Martin Place OSD DRP – Session 07 18.12.18:

Martin Place Metro

DRP - 8

METRO MARTIN PLACE | SOUTH TOWER

Tower built form relationships - Updated Proposal

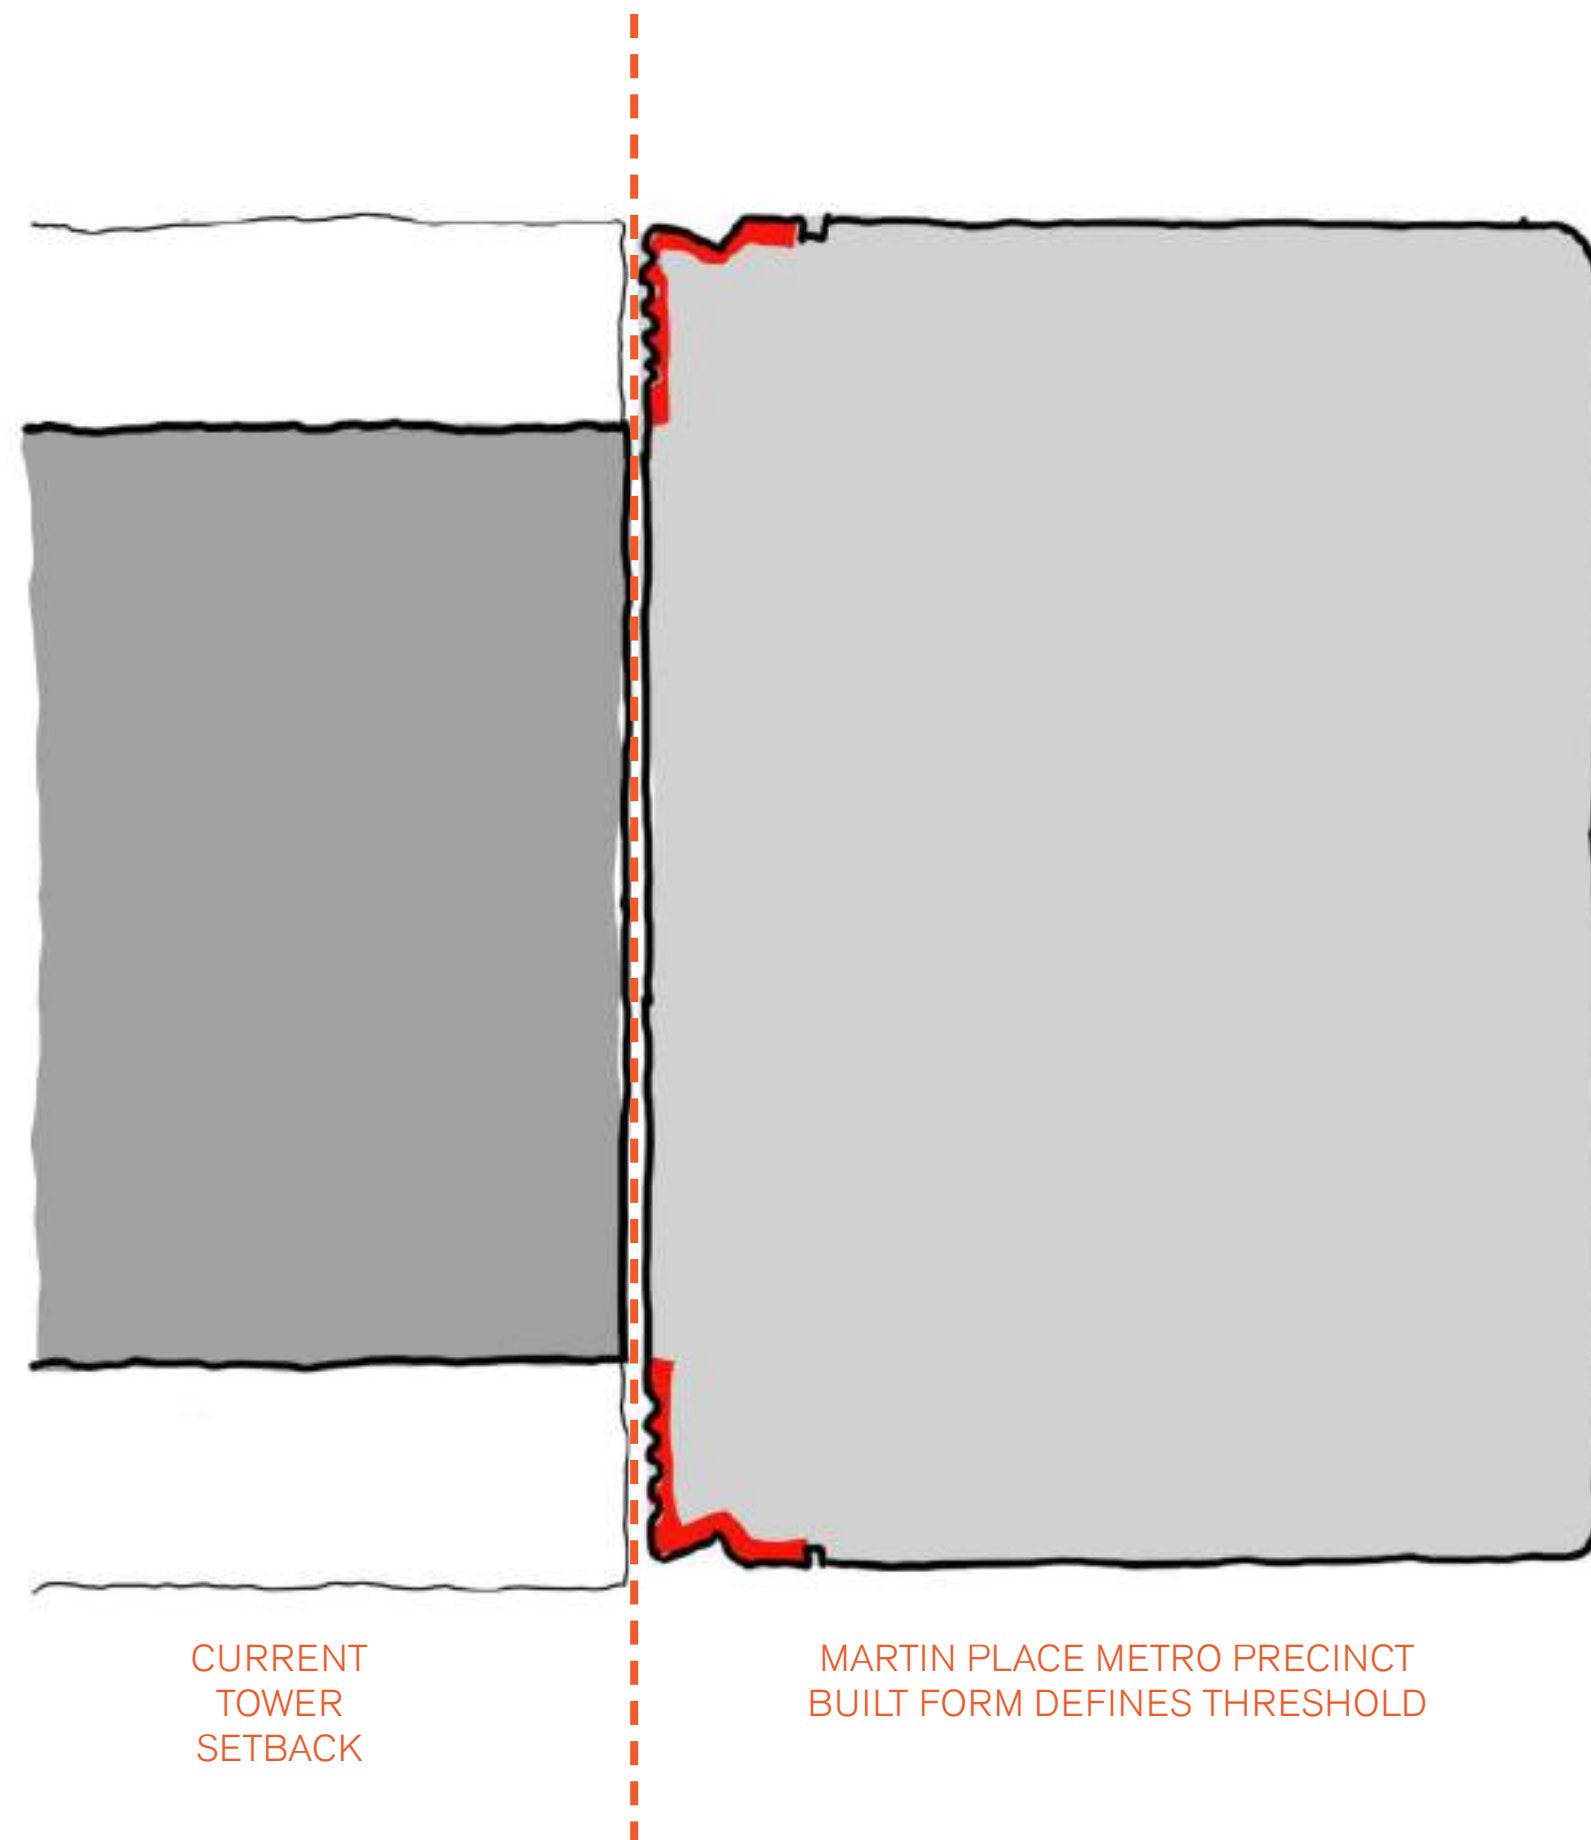
“While proposals to articulate and texture the tall southern facade go some way towards ameliorating the negative impacts of this wall, we remain concerned about its impact on urban design outcomes for the block. We note the tower floor plans above the podium level show more flexibility in the location of the structure than was previously understood which might allow articulation and detailing of the south east and south west corners of the tower to be reconsidered. Articulation of these corners would eliminate a continuous street wall, which would likely occur if future development to the south had no setbacks above the podium.”

_ Ensuring 39 Martin Place architecture at the S-E and S-W corners signify the threshold of the Martin Place and Martin Place Metro precincts.

_ Ensure integrity of southern facade, the S-W and S-E corner with the podium / tower architecture.

DRP 07 Proposal

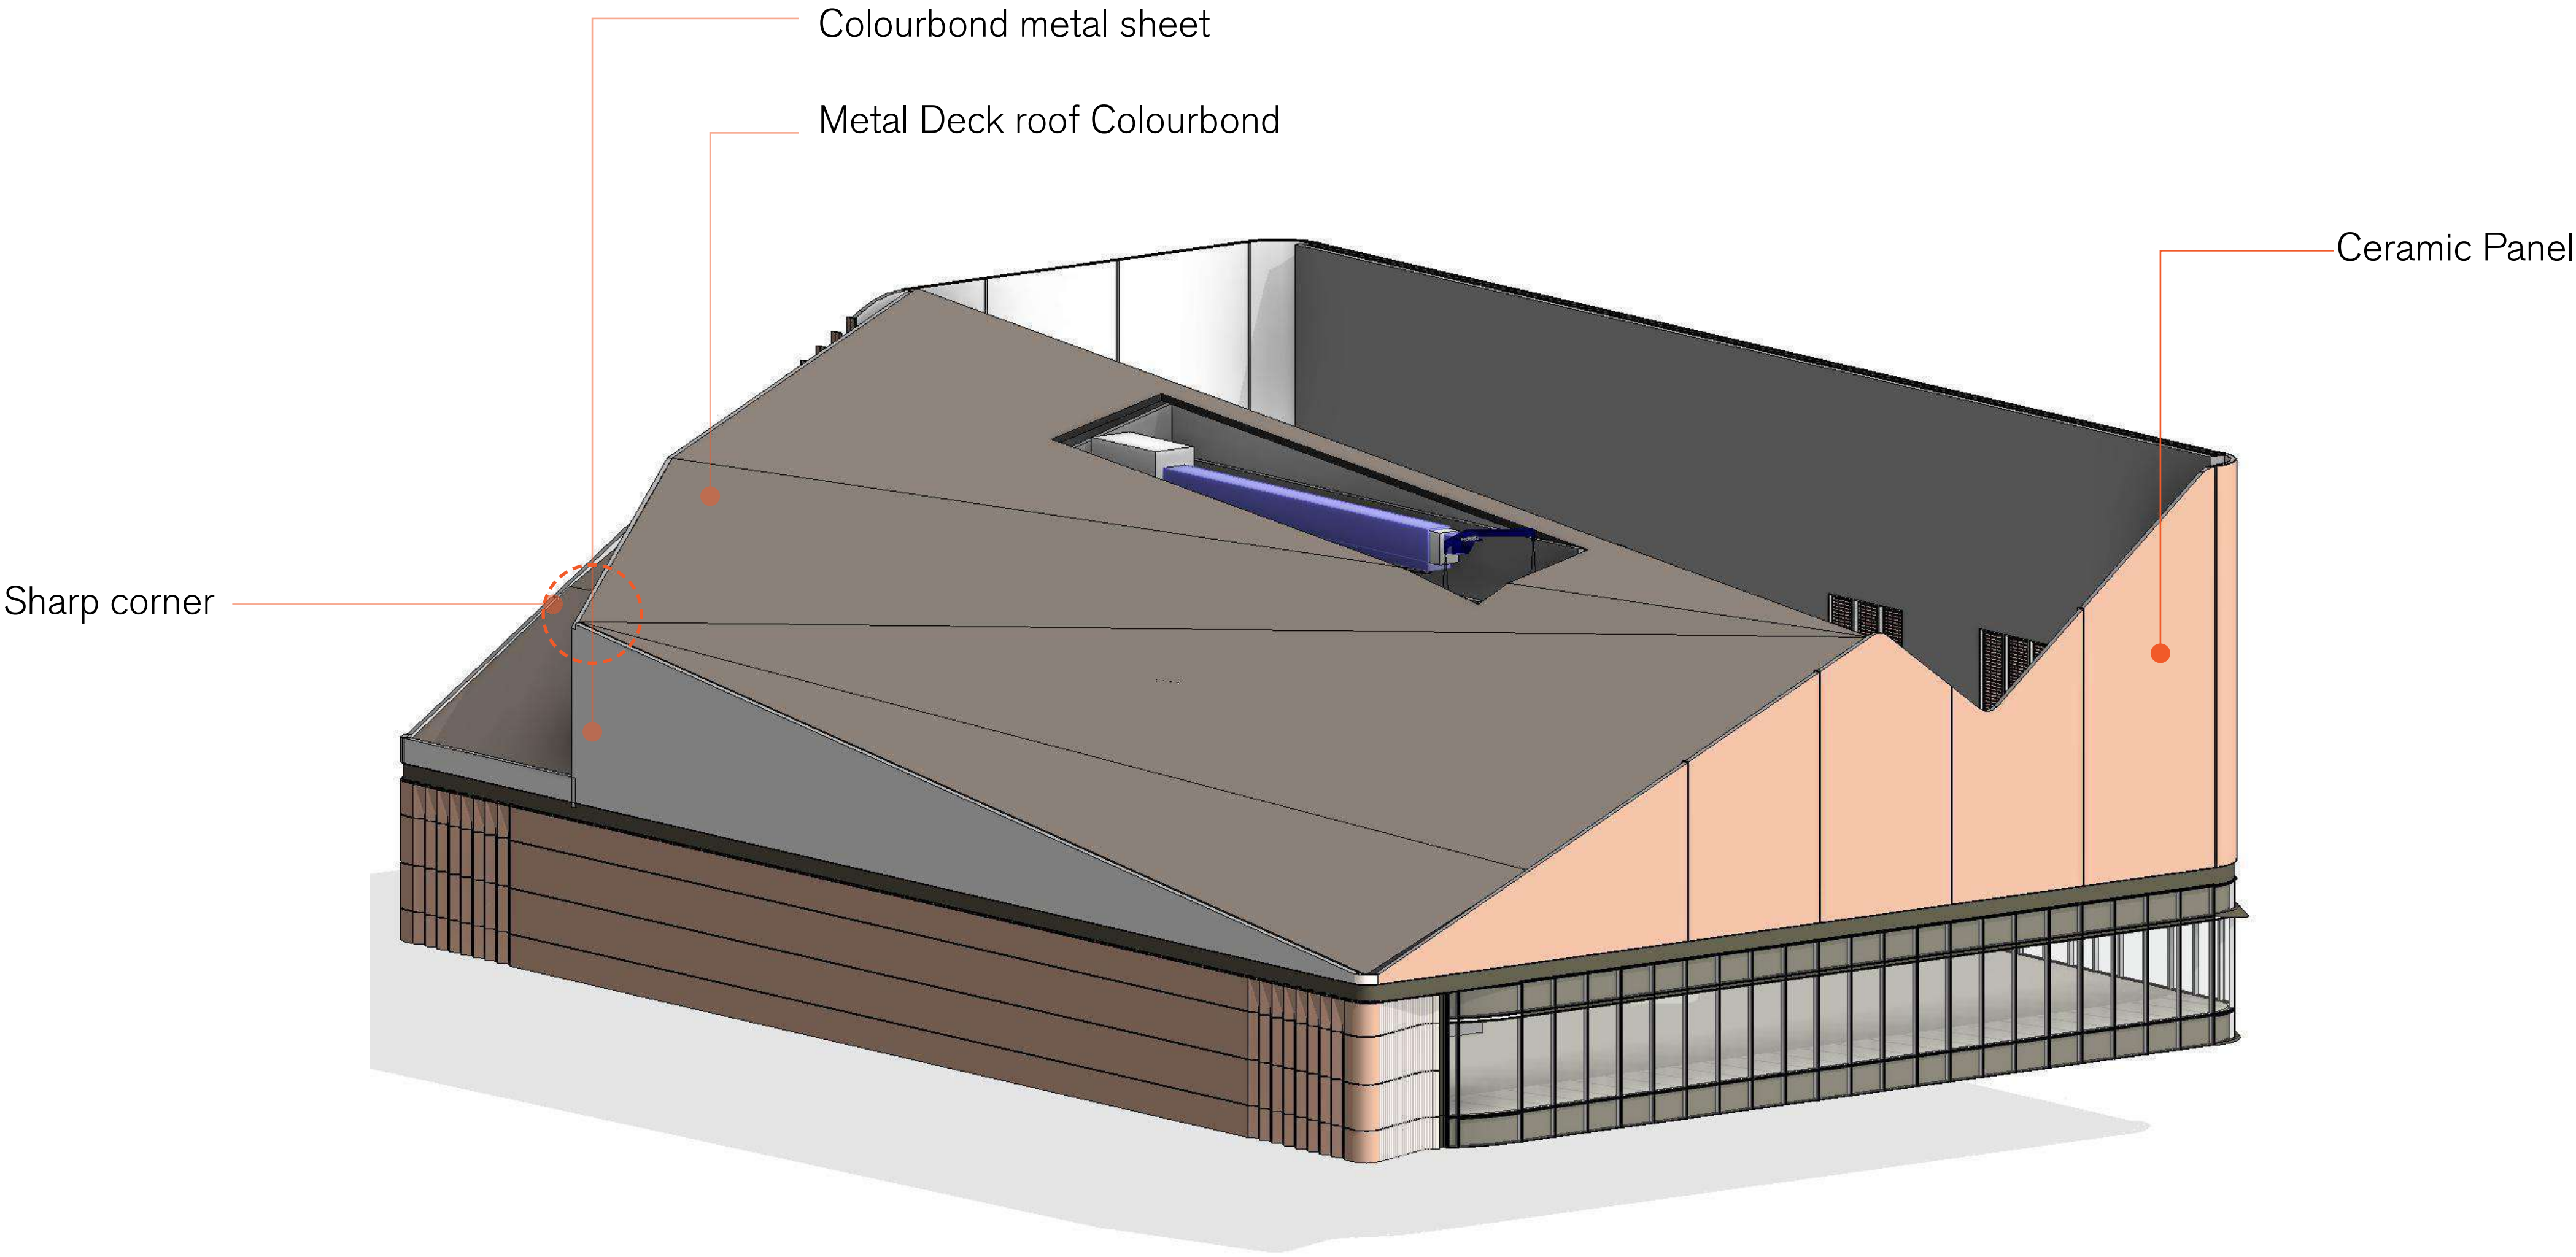
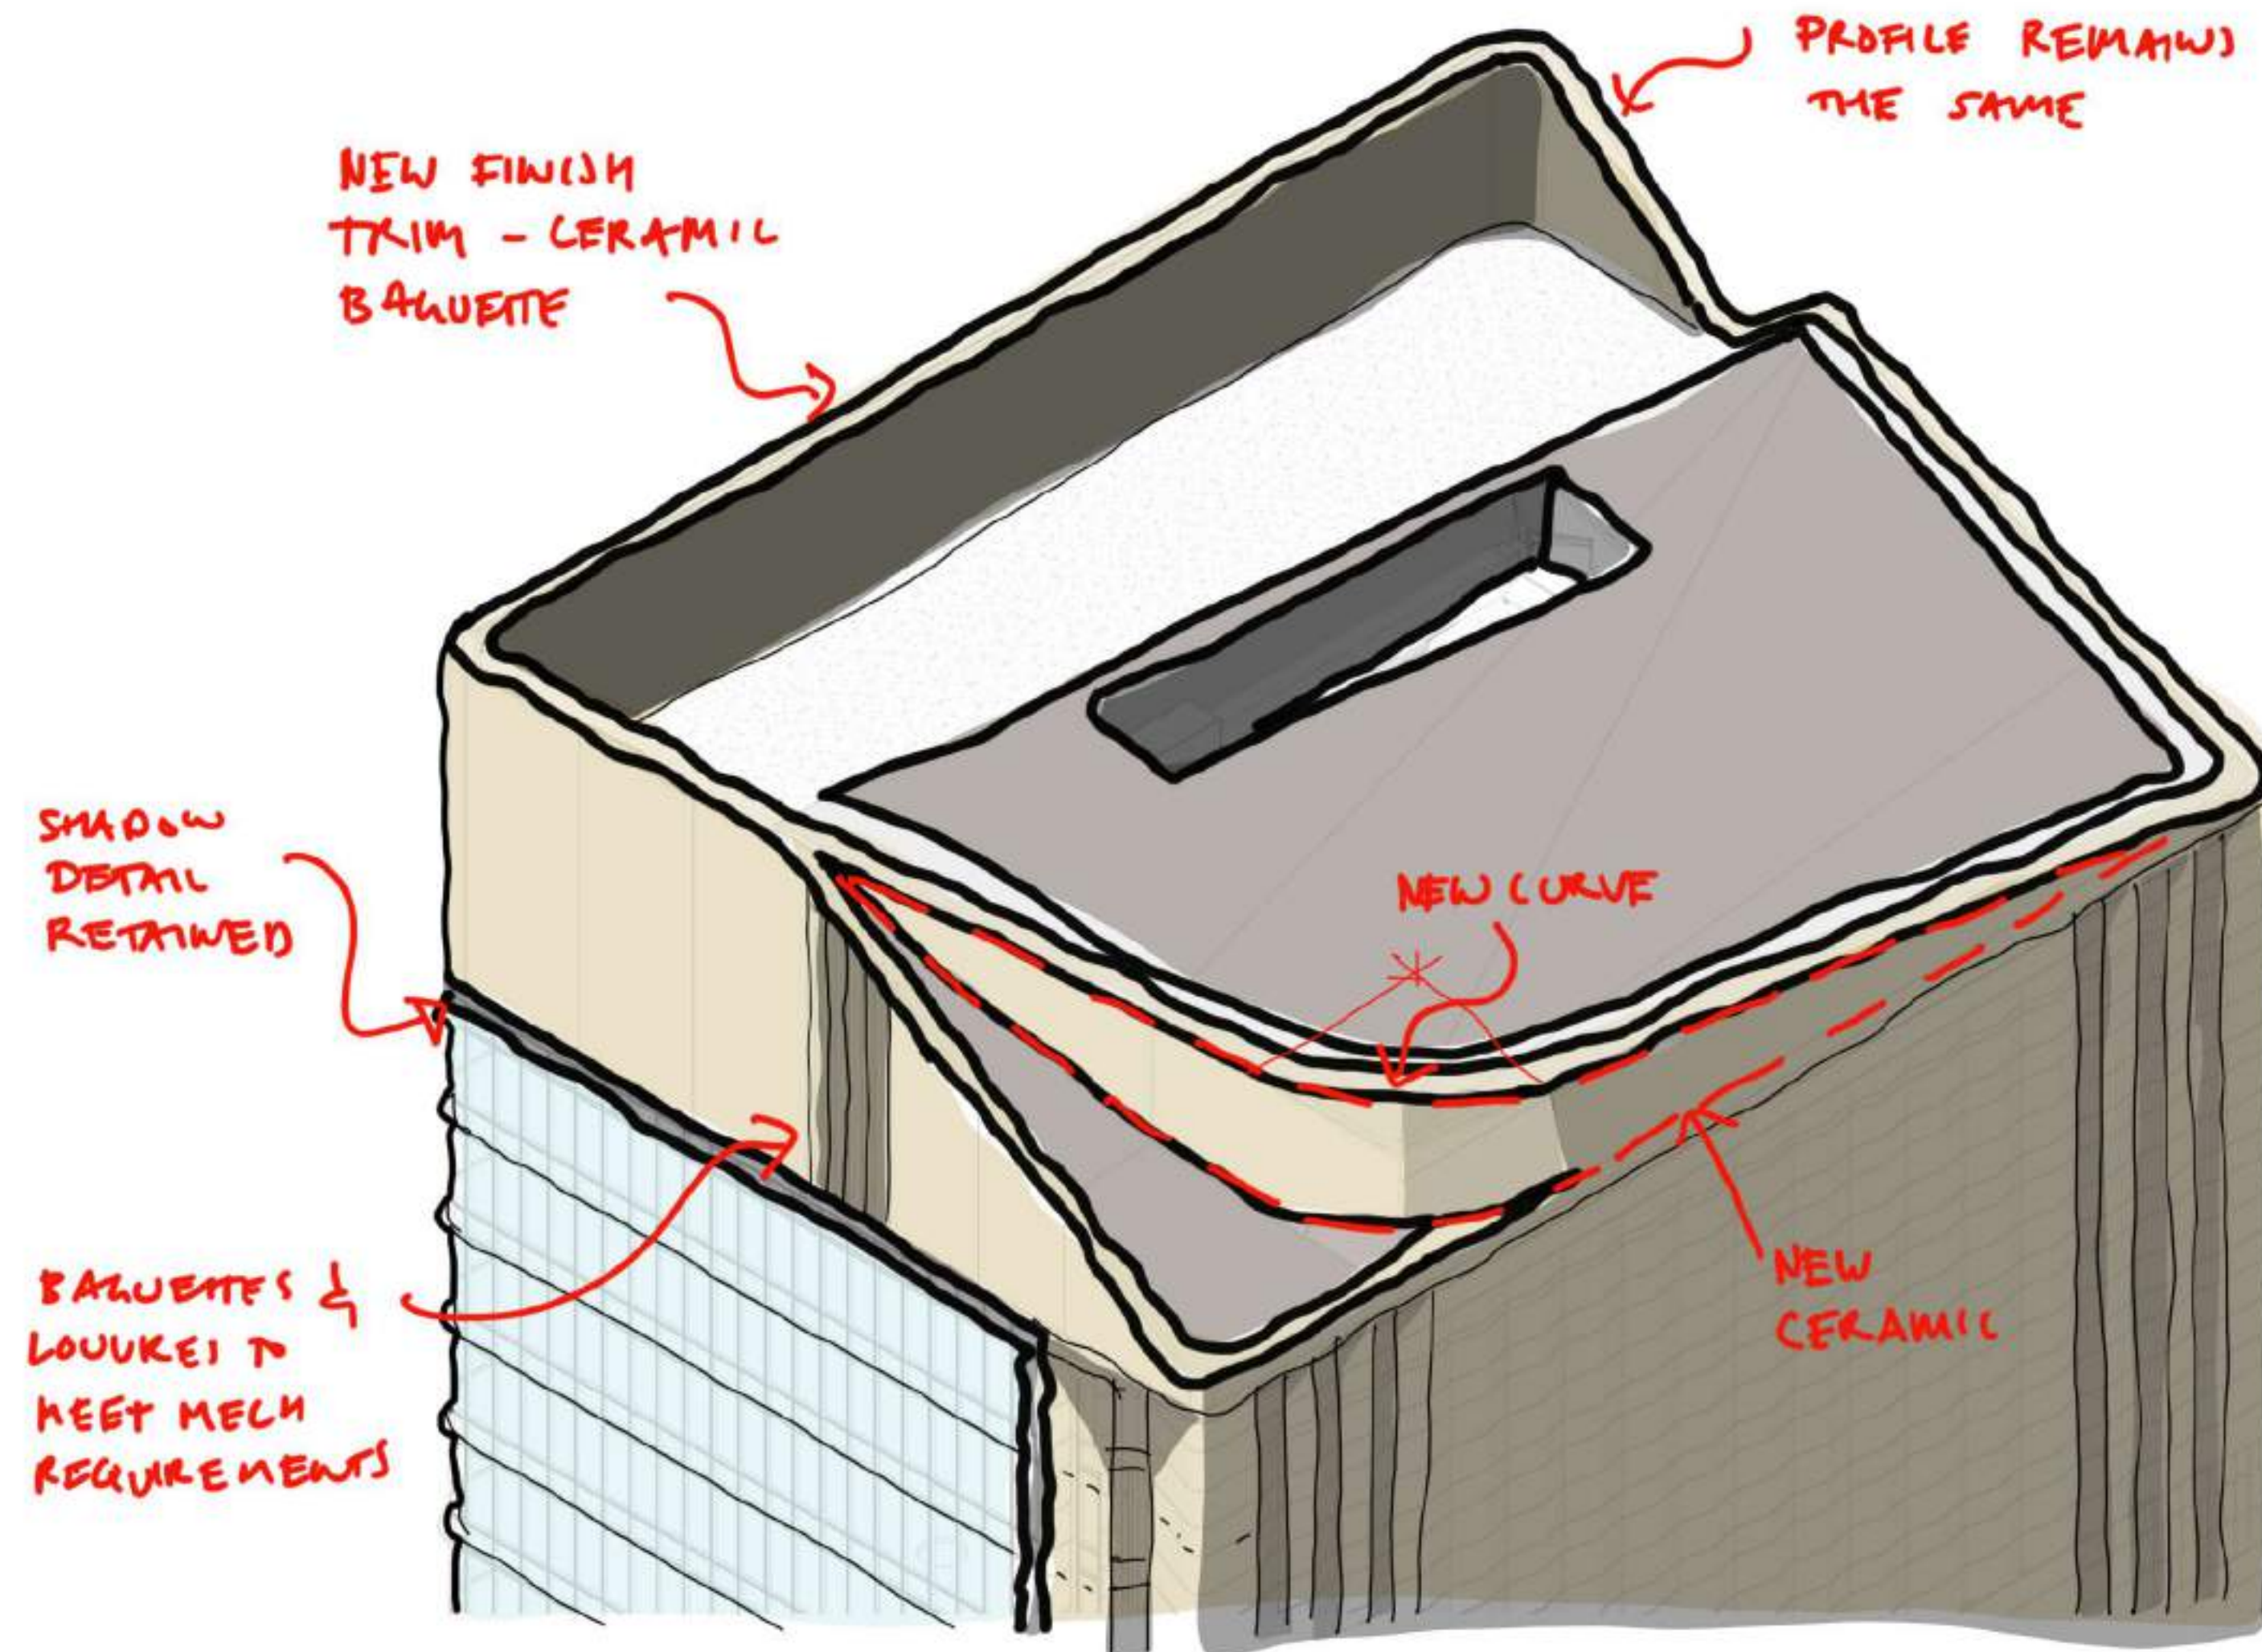
“Clarification of the resolution of the top of the building (which currently shows an ‘open’ plant enclosure).”

Updated proposal, roof design principles
